Stanwood High School Stanwood-Camano School District

Commissioning Report October 2023

**Commissioning Report for
Stanwood-Camano School District
Stanwood High School**

Project: Stanwood HS
Report Date: DD review, 5/17/18, response 6/27/18, DD back check and
Constructability 10/12/18, Bid back check 11/12/18
Reviewers: Byron Holmstead, Jake Huang
Drawings: 3/30/2018, 10/1/18
Specifications: 3/15/2018, 10/1/18

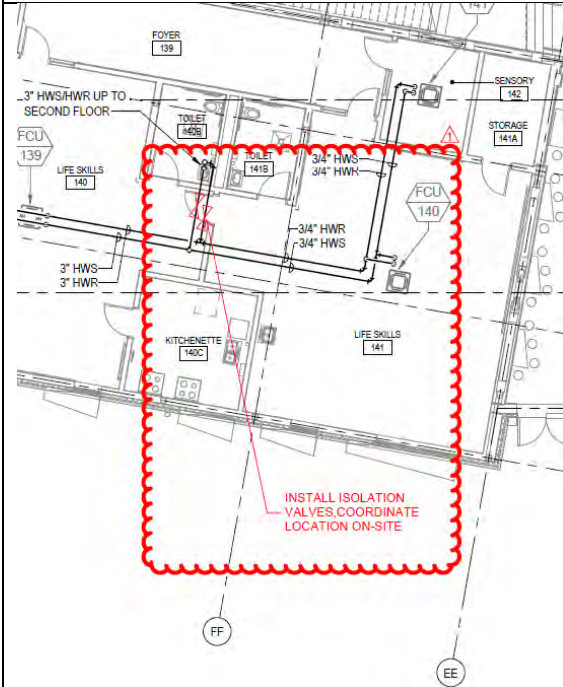
Isolation valves are already installed here but very high near the floor above. It may be more maintenance friendly to install on floor above.

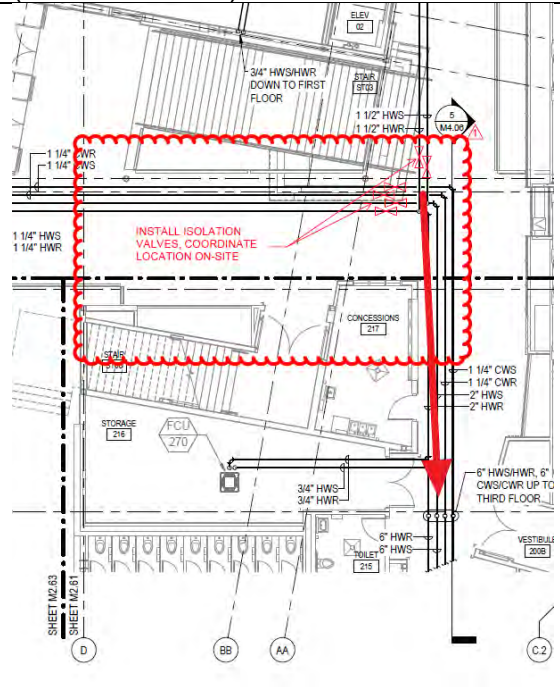
Recommend moving these proposed isolation valves to the south as shown below. Save money and better access (not above stairs).

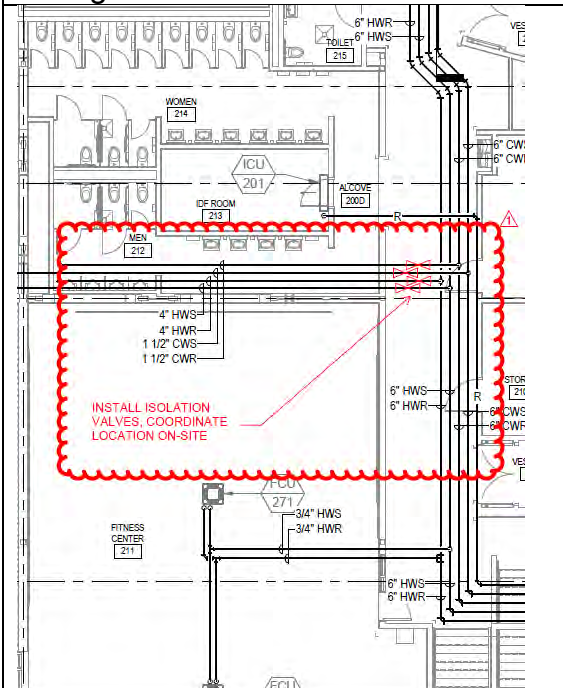
This location for isolation valves below may be too confining. May need to move to restroom ceiling or Admin ceiling.

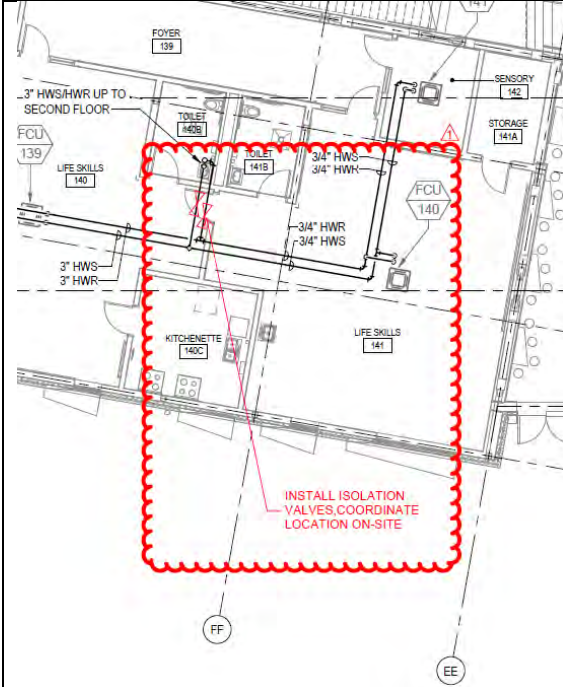
Isolation valves are already installed here but very high near the floor above. It may be more maintenance friendly to install on floor above.

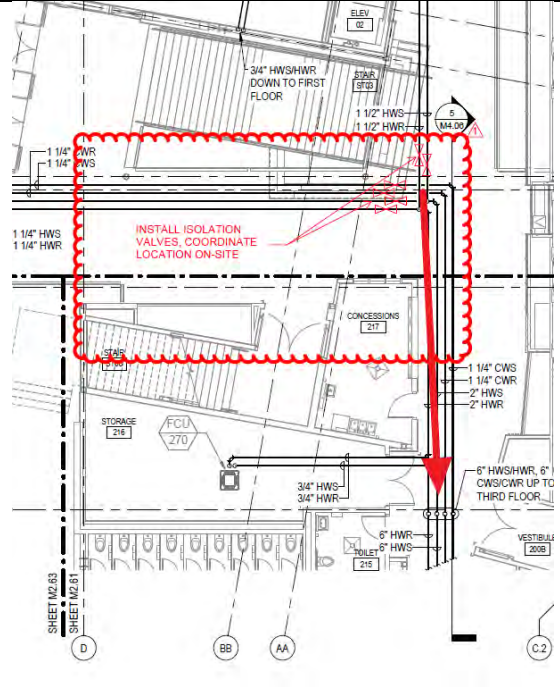
Recommend moving these proposed isolation valves to the south as shown below. Save money and better access (not above stairs).

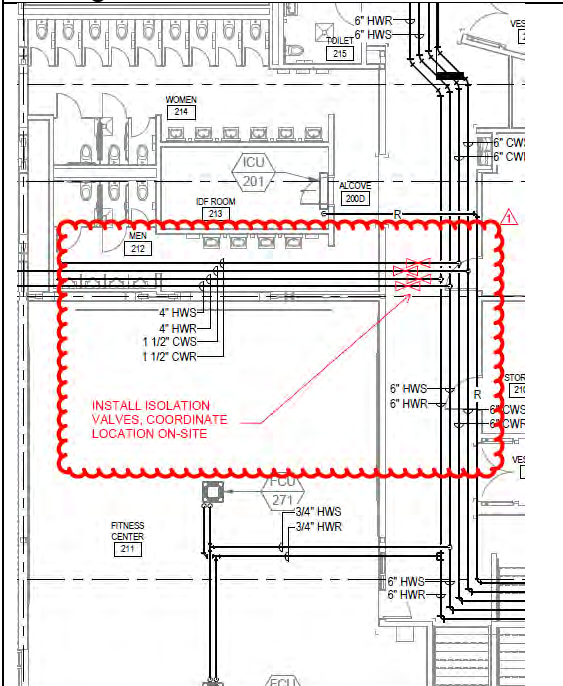
This location for isolation valves below may be too confining. May need to move to restroom ceiling or Admin ceiling.

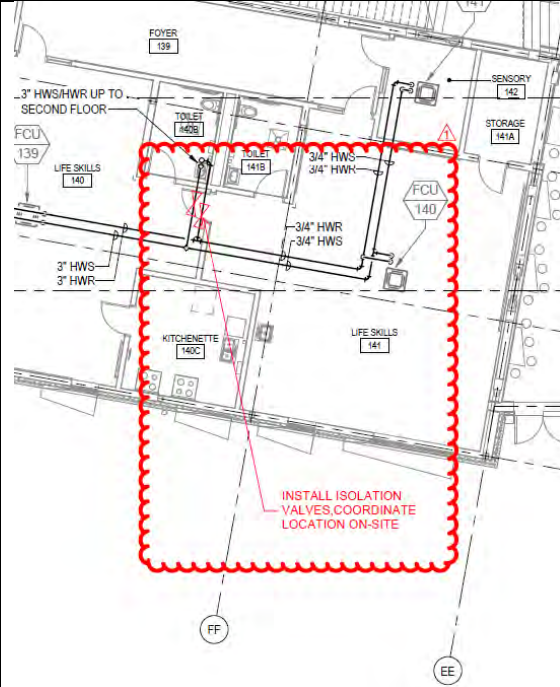
Isolation valves are already installed here but very high near the floor above. It may be more maintenance friendly to install on floor above.

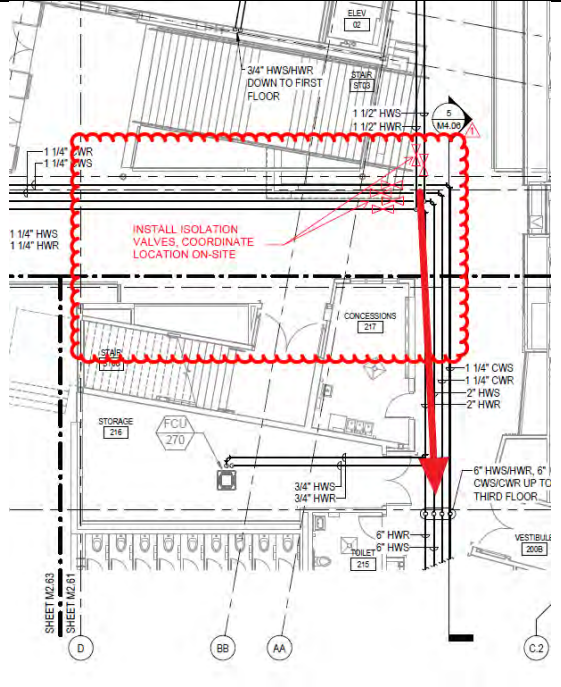
Recommend moving these proposed isolation valves to the south as shown below. Save money and better access (not above stairs).

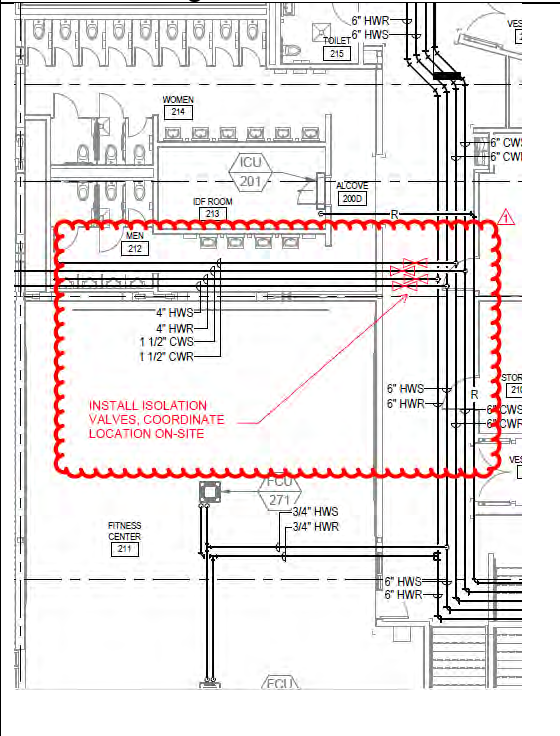
This location for isolation valves below may be too confining. May need to move to restroom ceiling or Admin ceiling.

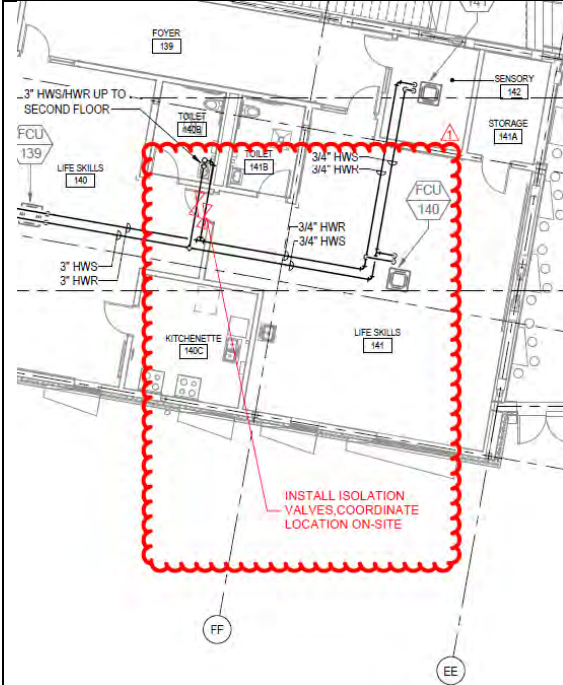
Isolation valves are already installed here but very high near the floor above. It may be more maintenance friendly to install on floor above.

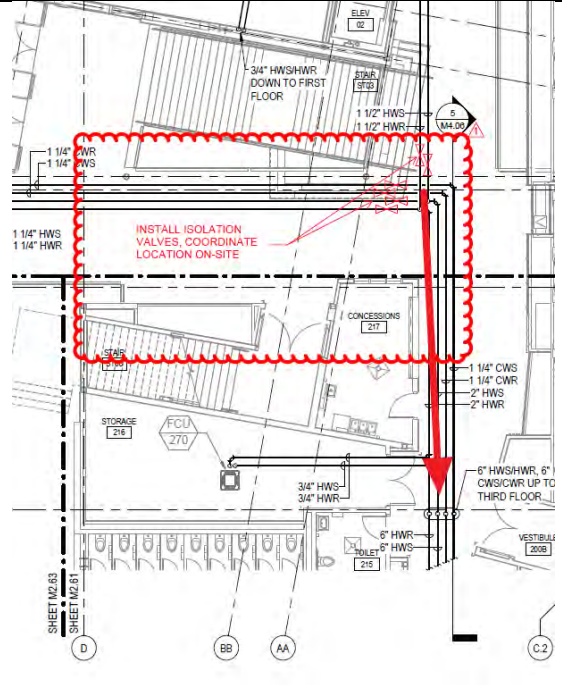
Recommend moving these proposed isolation valves to the south as shown below. Save money and better access (not above stairs).

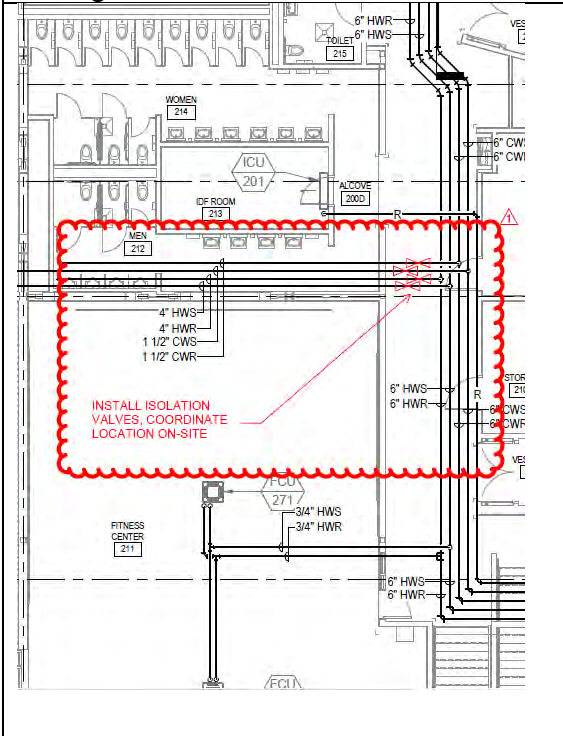
This location for isolation valves below may be too confining. May need to move to restroom ceiling or Admin ceiling.

DOAU-01 Motor access and missing filter.

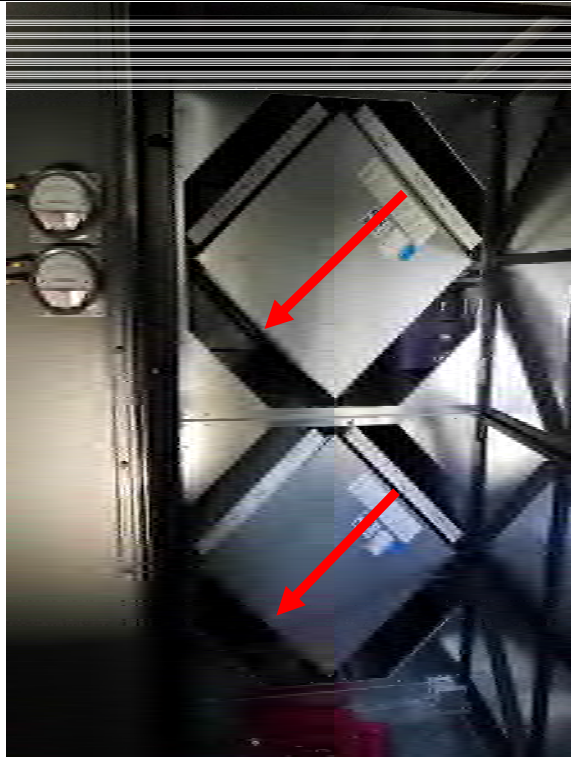
It appears that the exhaust filters are not located in correct location for DOAU-1 at the CTE building. The filters should be moved to location shown below.
